Rezoning Transportation Analysis

Petition Number: 2023-033

Date	Description
7-26-23	First Review (IW)
08-24-23	Second Review (NK)
9-20-23	Third Review (NK)
10-25-23	Fourth Review (NK)

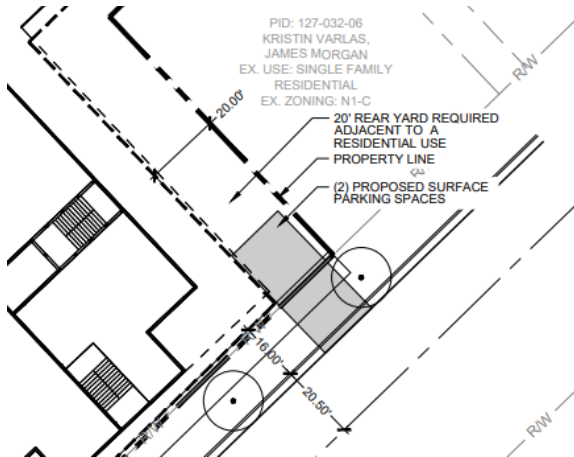
9. **Outstanding comment 7-26-23:** Provide additional information regarding Optional Provision II and requested maneuvering.

Clarifying Comment 8-24-23: It is unclear whether proposed parking spaces are encroaching on the required streetscape on Clement and Lamar Ave., provide additional clarification.

Clarifying Comment 9-20-23: Remove the additional parking spaces on Clement and Lamar Ave. Access to parking spaces is not allowed over a streetscape. This access would be considered a driveway and would be required to meet minimum driveway standards including geometric design, spacing, and internal stem requirements.

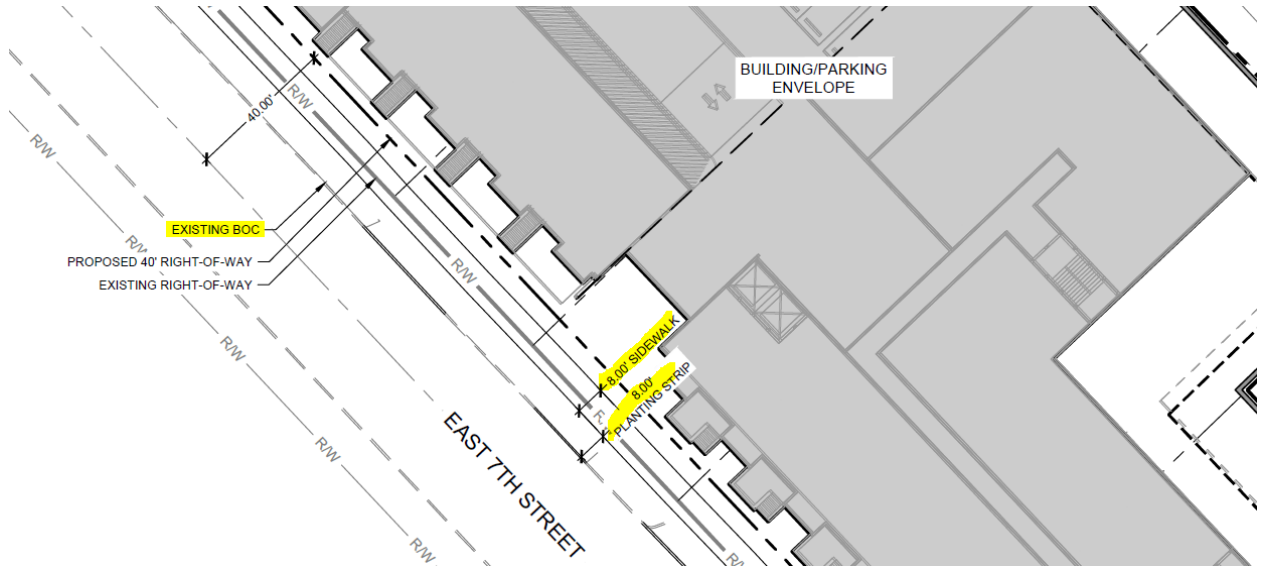
13. **New Comment 10-26-23:** Revise site plan to show future curb line located 27’ from centerline of E. 7th Street. Preservation of future curb line allows installation of bicycle facilities in the future to include buffered bicycle lanes. Preservation of space for future buffered bicycle lanes meets Council-adopted Charlotte BIKES policy. Current plan revision removed preservation of space for bicycle facilities and does not accommodate any form of future bicycle facilities.

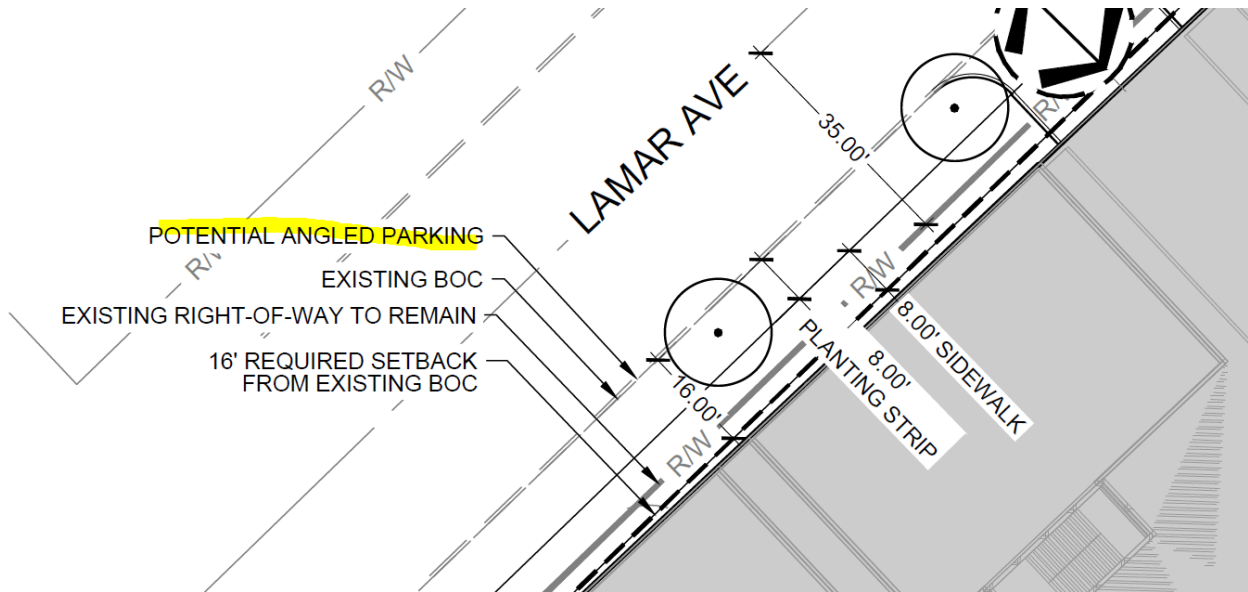
14. **New Comment 9-20-23:** ~~Revise site plan to eliminate encroachment of building and building entrances into the right-of-way.~~
